CITY OF ALBUQUERQUE

Re: Mountain America Credit Union, 8021 Ventura St. NE
Request for Permanent C.O. –Accepted
Engineer's Stamp Dated: 5-18-12, (D20/D010A)
Certification Dated: 1-30-13

PROJECT: MOUNTAIN AMERICA CREDIT UNION
ALBUQUERQUE BRANCH
PASEO DEL NORTE & VENTURA ST. - PARCEL B
ALBUQUERQUE, NM 87109
EMA ARCHITECTS | 800 WASHINGTON BLVD. - OGDEN, UT 84001 | PH: 801-616-3463

A1 GRADING PLAN
1" = 20'

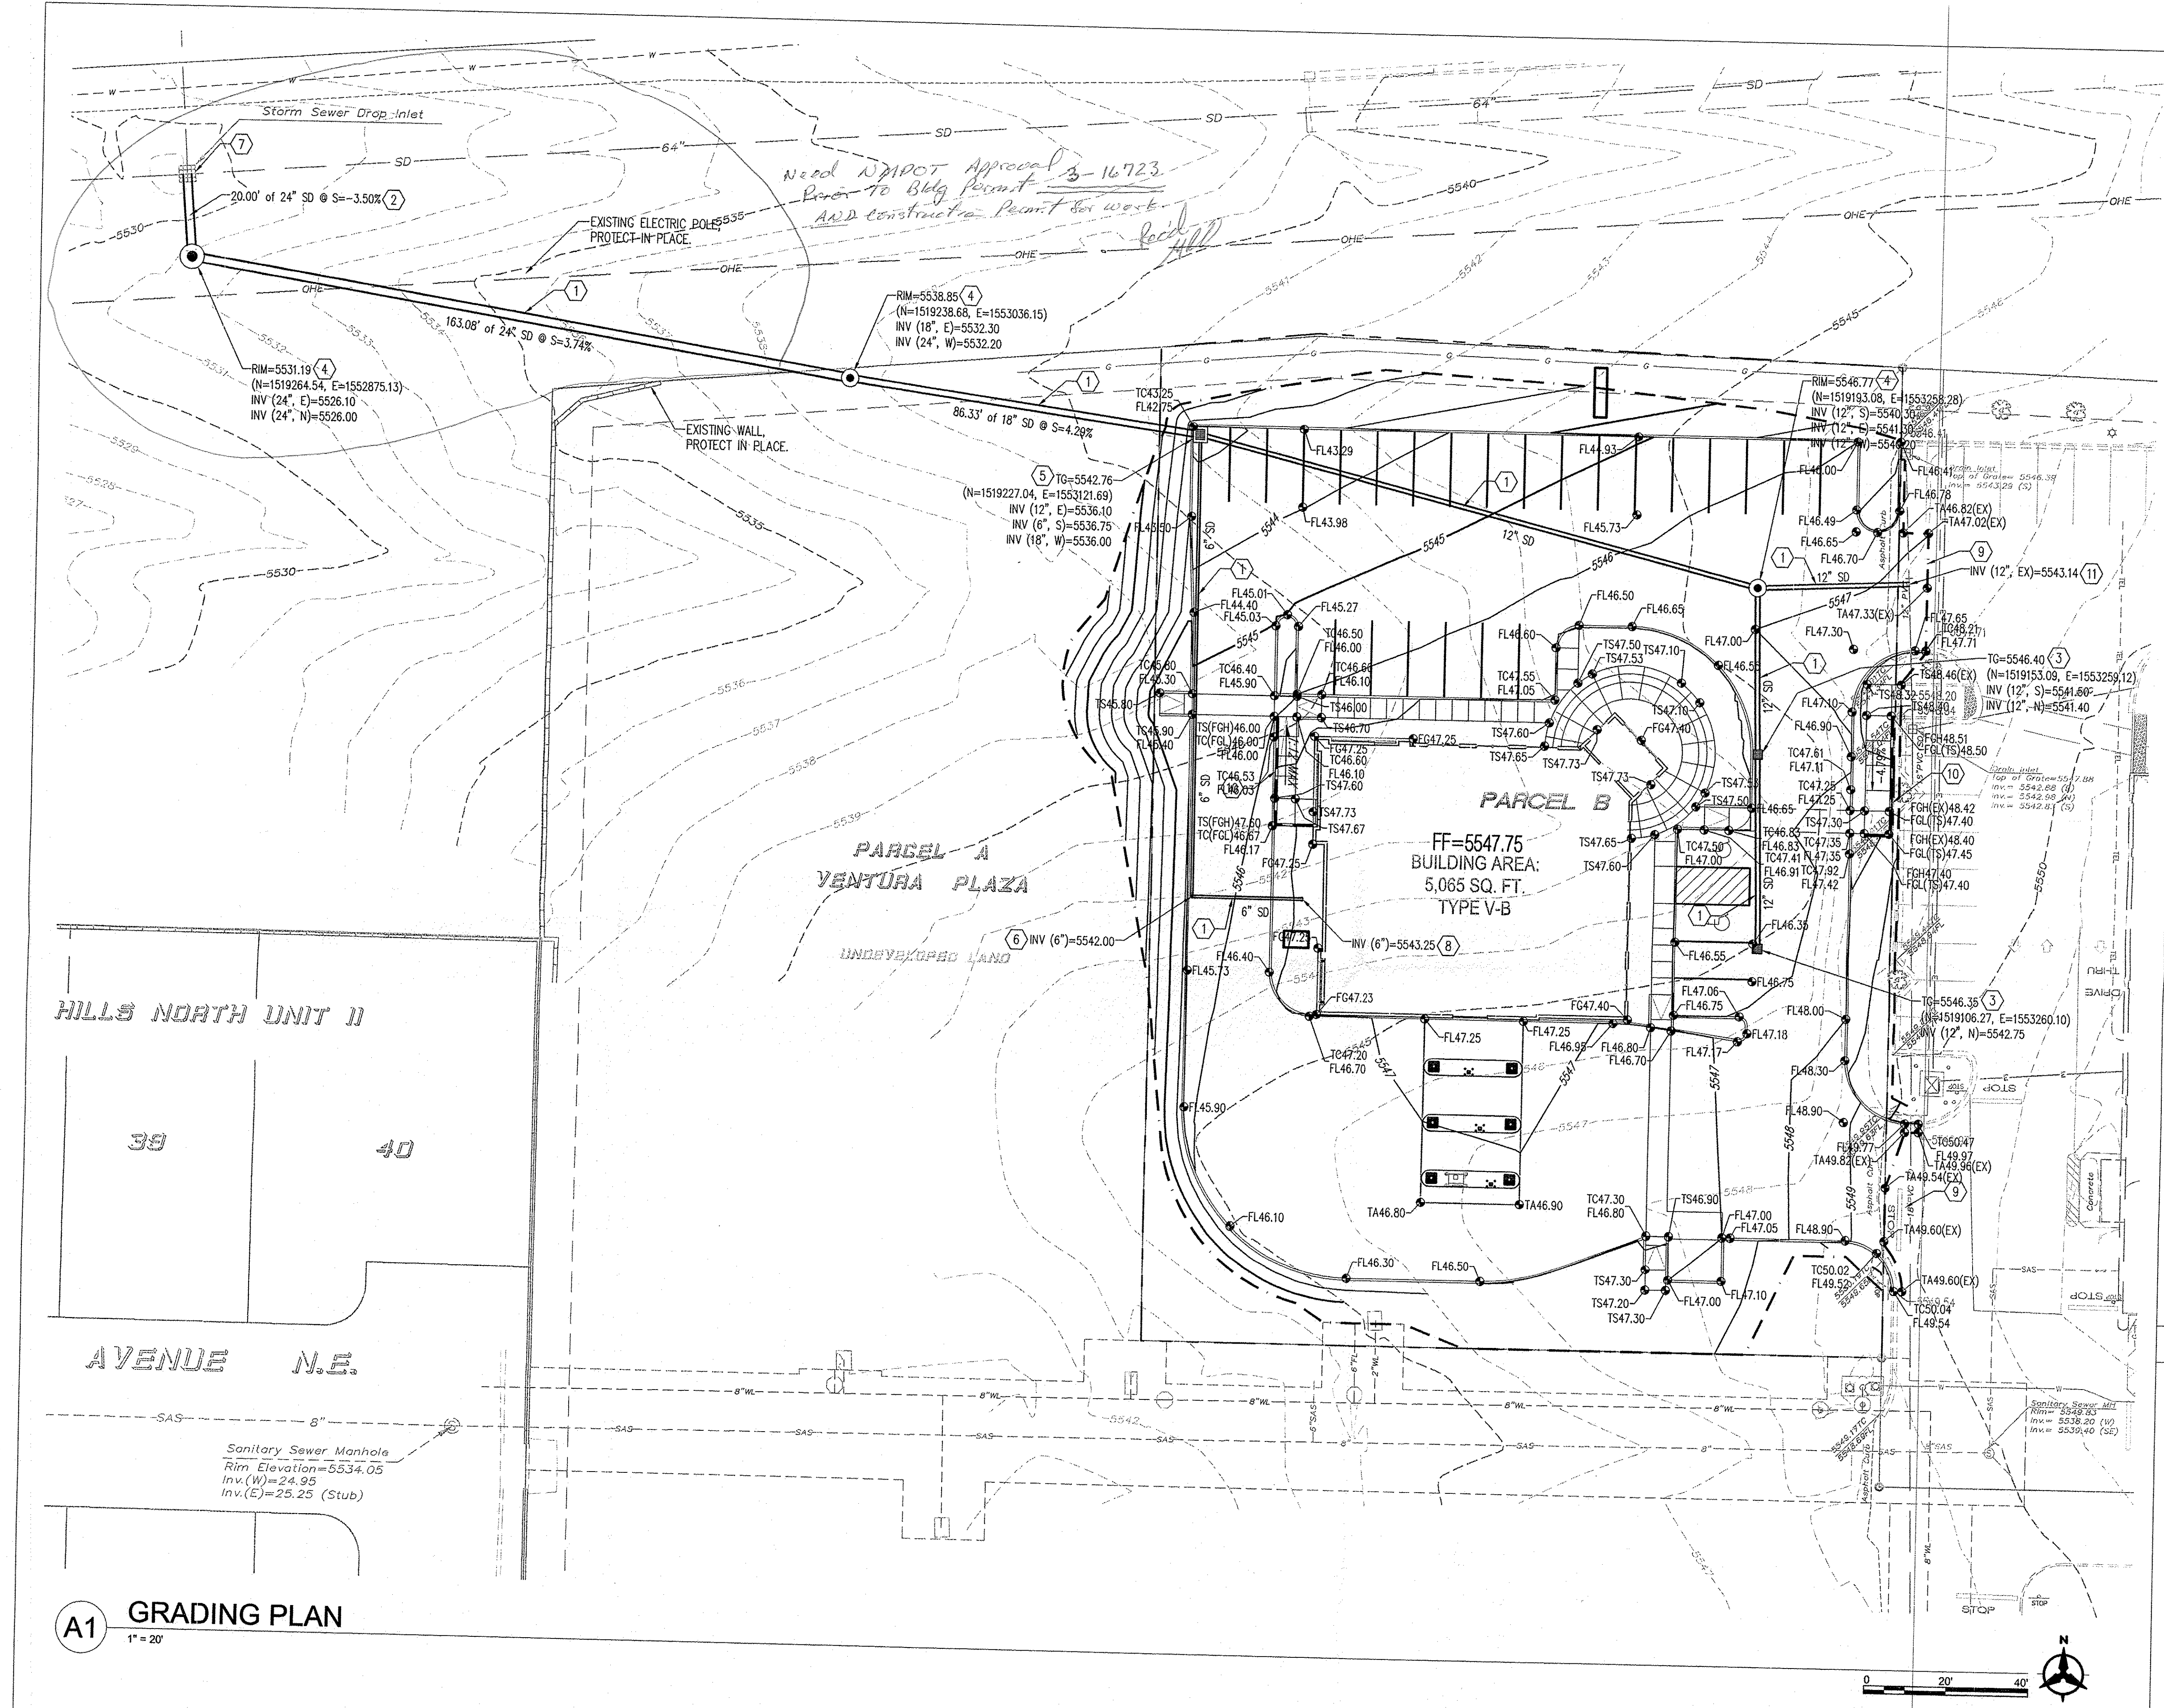
At Inlet for DWP.

Grading map on cert. Provide Loc. MAP on CERT.
